UNITED STATES PATENT AND TRADEMARK OFFICE

Office Action Summary

10/044,368

DETAILED ACTION

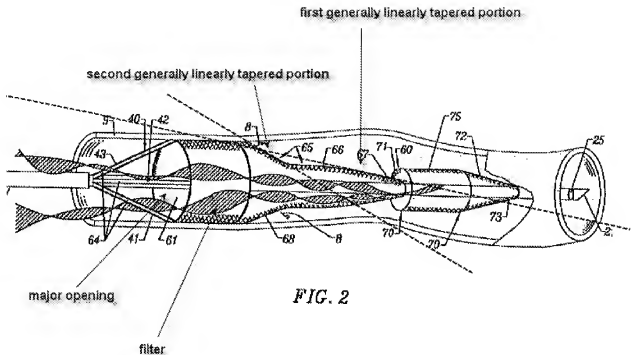
(claims 52, 58-63, 70-72, 78-83, 92 and 93) Stanford discloses a filter assembly comprising an elongate shaft **20**, a filter disposed and attached to a distal end of the shaft (see attached Fig. 2 below, or even in Fig. 15), the filter including a filtering region (the open portion) and an attachment region; wherein the filtering region includes a major opening defined adjacent the proximal end (see figure below) and is comprised of only a single layer of filter membrane that defines a filter basket and extending between the major opening and the distal end of the filtering region, the filtering region comprising apertures to allow the passage of blood through the filtering region; the filter membrane further comprising a first "generally linearly" tapered portion defining a first angle that is lesser (or different) than a second angle defined by a second "generally linearly" tapered portion (see figure below); wherein the filter has an expanded (Fig. 2) and contracted shape (Fig. 3); wherein the first tapered portion extends at the first included angle for a "substantial length" of the first tapered portion and the second tapered portion extends at the second included angle for a "substantial length" of the second tapered portion.

(claim 90) The second tapered portion extends proximally from the proximal end of the first tapered portion (see figure above).
